**RE: *COA-23-003 (ZON-23-020) 139 N County Road (Paramount Theatre)
Responses to Volkert, Inc. Comments
Palm Beach, Florida
KH #241020000***

Kimley-Horn [K-H] Traffic Impact Evaluation (Revised February 9, 2024)

Paramount Theater Site Plan Submittal (Submitted February 12 and February 21, 2024)

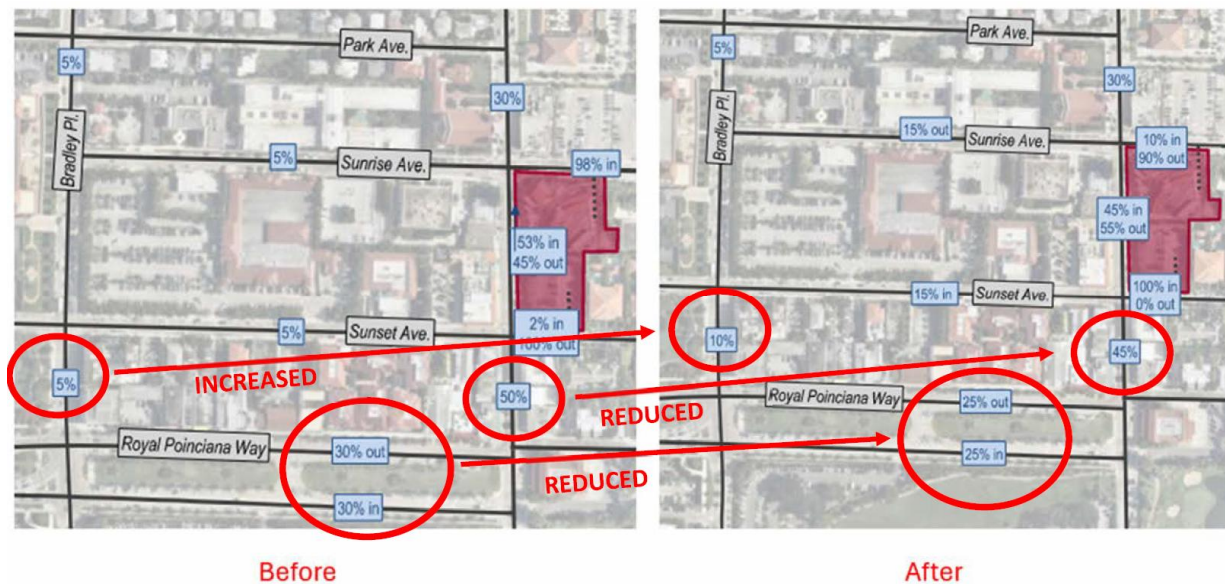
- a. The study and the site plan show the ingress on Sunset Avenue and egress on Sunrise Avenue, but Figure 1 shows 10% of the vehicles entering the property on Sunset Avenue and shows 100% on Sunrise Avenue. In addition, only 90% of the trips exit on Sunrise Avenue, not 100% as shown on the site plan and described in the report (see Figure 4 below).
 - i. Detailed distribution and assignment figures should be included that show inbound and outbound patterns clearly and accurately. Separate figures for distribution in and out, with directional arrows should be included for clarity.
- b. The project distribution percentages and assignment trips were changed from the previous submittal, with no explanation.

The change reduces the project trip impacts significantly at both the Royal Poinciana Way and Sunset Avenue intersections along North County Road and increases trips on roadways like Bradley Place, the site of a Publix Market, the only large supermarket serving the Town of Palm Beach. It should be noted there is severe congestion along both Bradley Place and North County Road, as seen in Photos 1 and 2, respectively.

- i. The volume of project traffic using Royal Poinciana Way was reduced to 25%, from 30%, which ultimately reduces the impact at the higher volume intersections and erroneously represents the project impacts.

RESPONSE: The trip distribution figure has been updated for clarity. Ingress is only available at the southern driveway. The “10% in” on Sunrise Avenue is inbound traffic coming from the east to the west, south on County Road, and then east to Sunset Avenue to enter at the southern driveway. Project traffic distribution was revised from earlier submittals per the direction of the Town. Further growth rate calculations have been conducted using roadway data counts using data from 2018 to 2024 and the updated growth rate calculations are provided in detail in the updated traffic study. Additional committed development traffic, including traffic associated with West Palm Beach projects, has been included in the revised analysis.
